Safety Audit Report

**New Highway Access
Meadowlands
Woodcroft Lane
Havant**

Feasibility Design Stage (F)

**Hampshire
County Council**

Drug No: 502728 / SKI ~~REVISED~~
REVISION D.

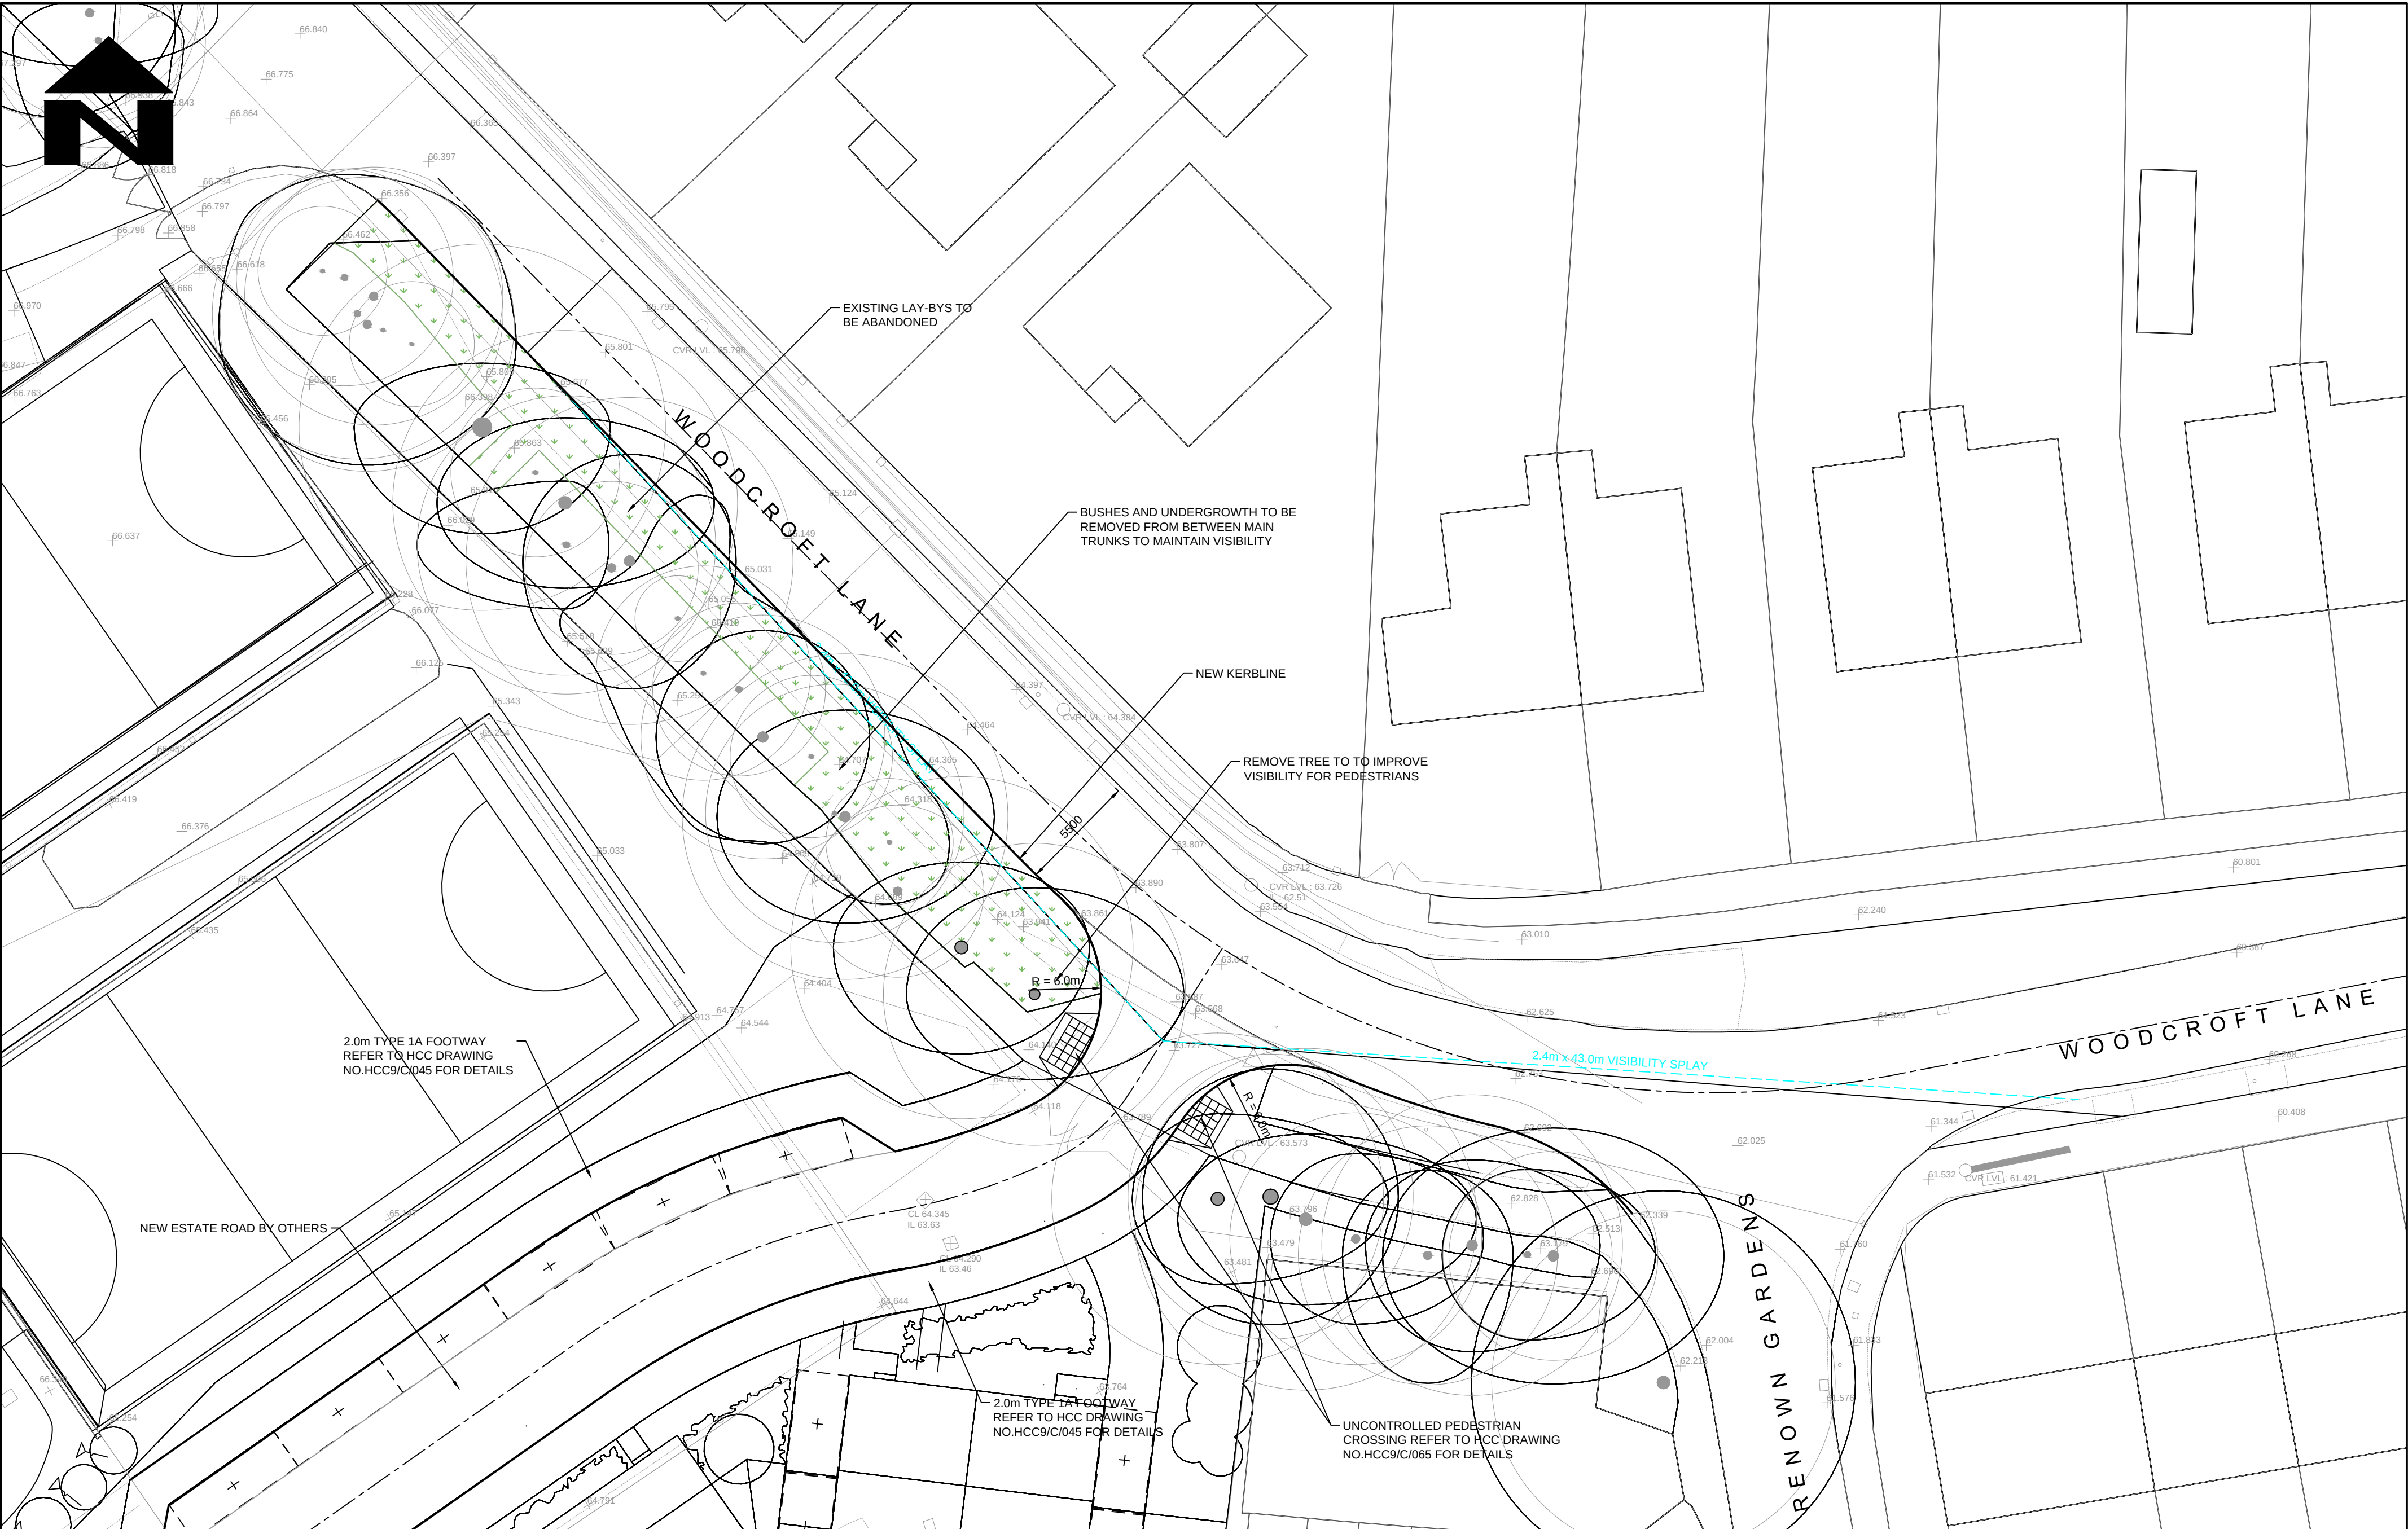
Location: The proposed pedestrian crossing point on the new access road.

Summary: The intervisibility between pedestrians and drivers may be obstructed by a tree.

The intervisibility between pedestrians stood on the north west side of the crossing point and drivers travelling south east along Woodcroft Lane will be restricted by an existing mature tree located close to the proposed junction. As a result pedestrians may walk out into the path of an oncoming vehicle.

Recommendation: Remove the tree to provided adequate visibility.
